RESPONSE TO REQUEST FOR ADDITIONAL INFORMATION

APR1400 Design Certification

RAI No.: 355-8438

SRP Section: 09.05.04 – Emergency Diesel Engine Fuel Oil Storage and Transfer System

Schematic Diagram of Diesel Fuel Oil Storage Tank HVAC System

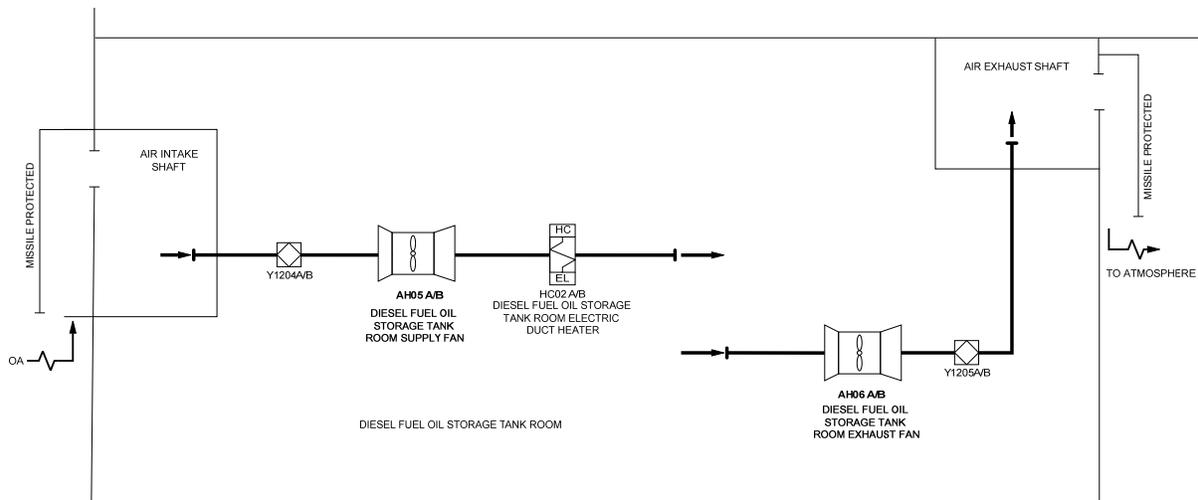
Please describe the codes and standards that will be applied to the coatings on the underground tanks, piping, and other components. In addition, describe your plans to add this information to the FSAR. This information is needed for conformance with position C.9 of Regulatory Guide 1.137, Rev. 2, which states that external corrosion should be addressed by following NACE International standard practice SP0169-2007, "Control of External Corrosion on Underground or Submerged Metallic Piping Systems." If SP0169-2007 is not being used, provide a justification for the proposed alternative. For additional background, the staff notes that License Renewal Interim Staff Guidance, LR-ISG-2015-01, "Changes to Buried and Underground Piping and Tank Recommendations," identifies loss of material on steel and copper components in underground vaults due to moisture in the air.

License Renewal Interim Staff Guidance, LR-ISG-2015-01, noted that “the typical air conditions in underground vaults have higher moisture content than uncontrolled indoor air conditions in plant spaces within buildings”.

In the APR1400 design, the diesel fuel oil storage tanks and associated piping are located in vaults, which have dedicated HVAC systems as described in DCD Tier 2, Subsection 9.4.5.2.1.3. Supply and exhaust fans for the diesel fuel oil storage tank rooms operate continuously to prevent possible accumulation of oil fumes and to provide ventilation during all modes of plant operation. The electric duct heater operates to maintain the minimum required room temperature in the diesel fuel oil storage tank room. A sketch of the dedicated HVAC system is shown below (DCD Tier 2, Figure 9.4.5-1 provides a more detailed drawing of the system).

Therefore, the air condition in the vault does not have higher moisture content than uncontrolled indoor air conditions in plant spaces within buildings.
